**TRANSWESTERN PIPELINE**  
An ENERGY TRANSFER Company

**RE: Second Response to Comments  
2017 Annual Report  
Roswell Compressor Station No. 9  
Transwestern Pipeline Company  
Roswell, Chaves County, New Mexico  
NMOCD Case #GW-052  
EPA ID No. NMD986676955  
HWB-TWP-18-001**

REMEDIATION SYSTEM LAYOUT

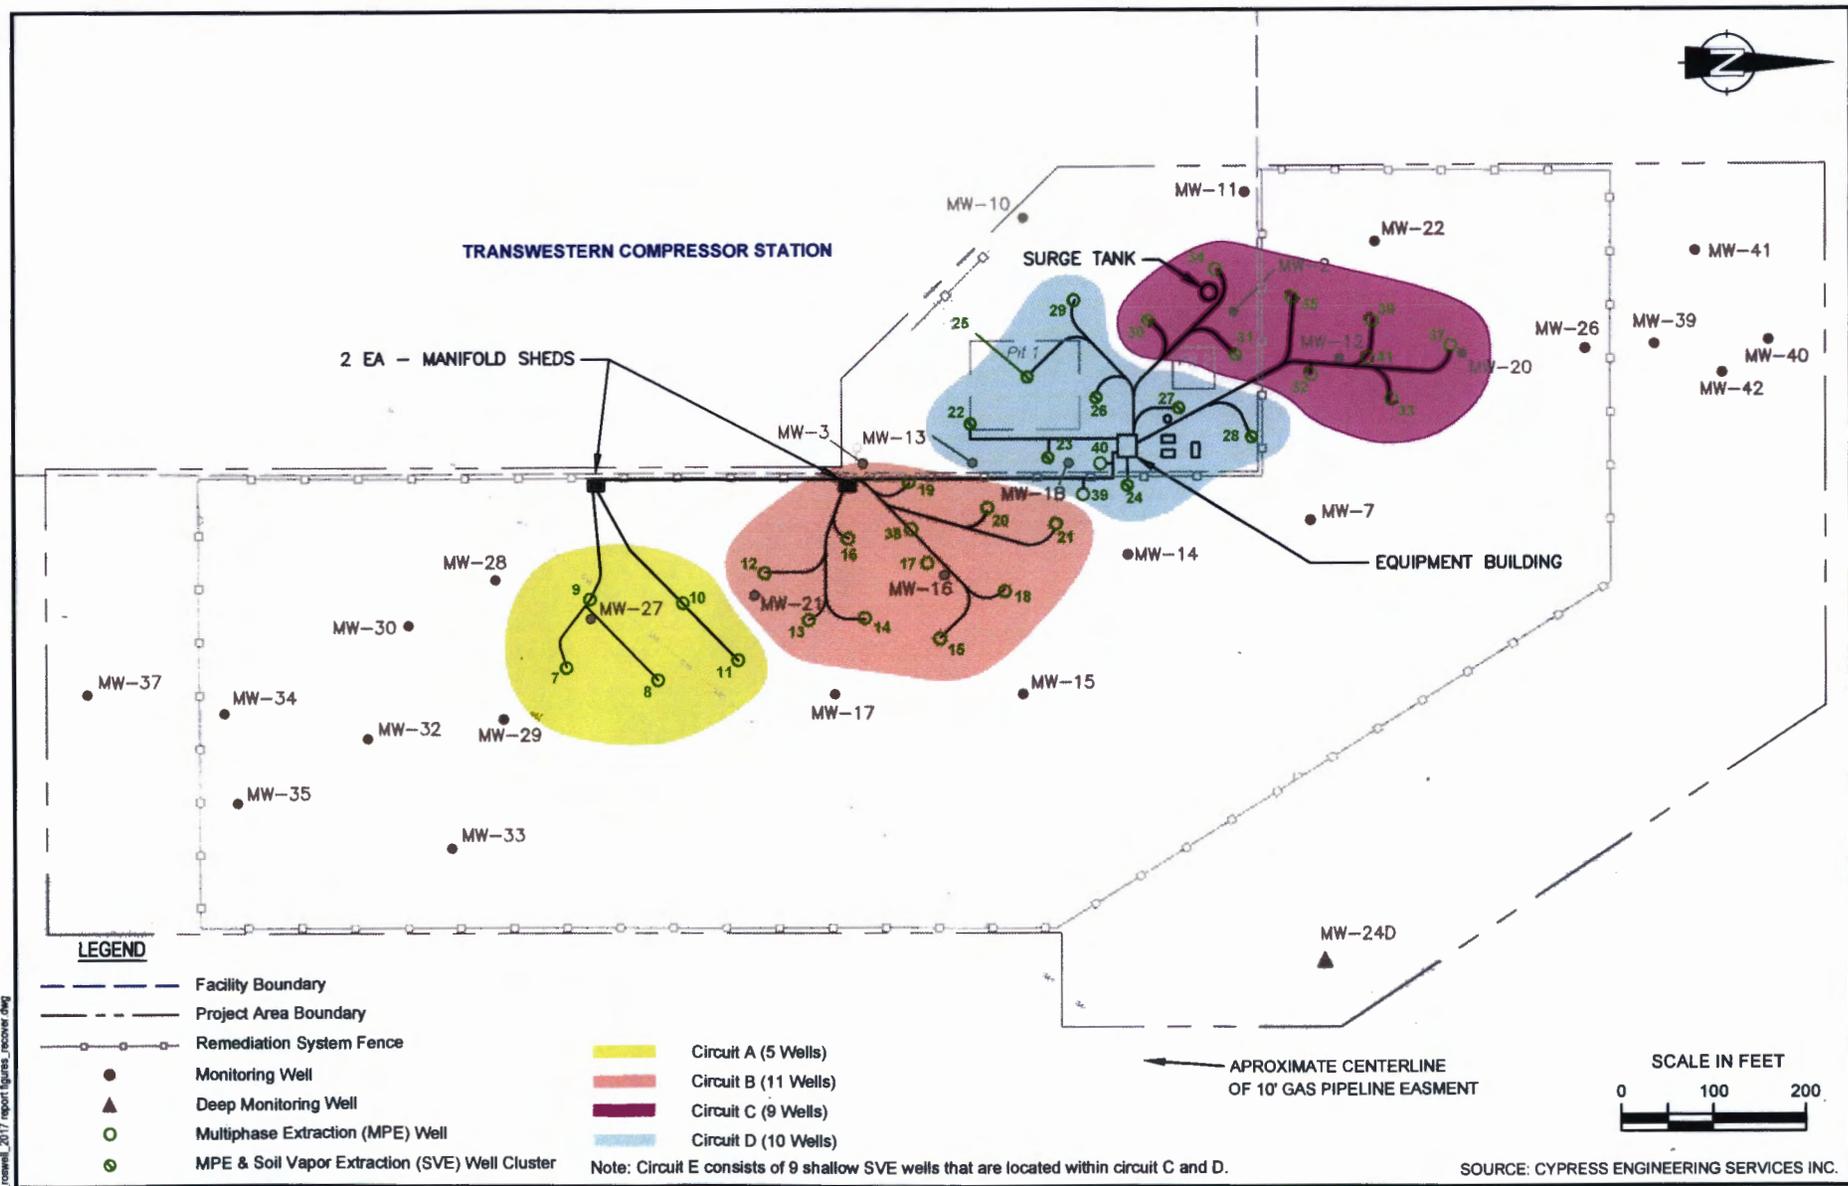
**The replacement pages included in Attachment A are not fully revised to reflect the changes required by Comment 6 of NMED's *Approval with Modifications*. There are discrepancies in the number of wells in Circuit C and Circuit D between Figure 1-3 and the text in the replacement pages. Provide replacement pages that address the revisions required by Comment 6. In addition, the Response Letter states that well MPE-21 was not included in the SVE optimization test; however, well MPE-21 appears to be included in Circuit B according to Figure 1-3. Revise Figure 1-3 to depict an accurate configuration of the remediation system. Furthermore, the note in Figure 1-3 states, "Circuit E consists of 9 shallow SVE wells that are located within Circuit C and D." No discussion was provided regarding Circuit E in the 2017 Report. Provide information about Circuit E in the response letter.**

Based on our review of the system optimization documents, MPE-21 was included in Circuit B for the SVE optimization test. Figure 1-3 was reviewed and updated to indicate the accurate configuration of the circuit. **Attachment A** contains the revised Figure 1-3 and replacement pages. Circuit E well grouping consists of nine SVE wells (SVE-22 through SVE-28, SVE-30, and SVE-31) which are collocated in a cluster with a MPE well (MPE-22 through MPE-28, MPE-30, and MPE-31). The SVE wells were installed at shallow depths (less than 45 feet below ground surface) above the groundwater to enhance recovery of vapor-phase hydrocarbons in the source area. The SVE wells operate in conjunction with the MPE wells located in Circuits C and D.
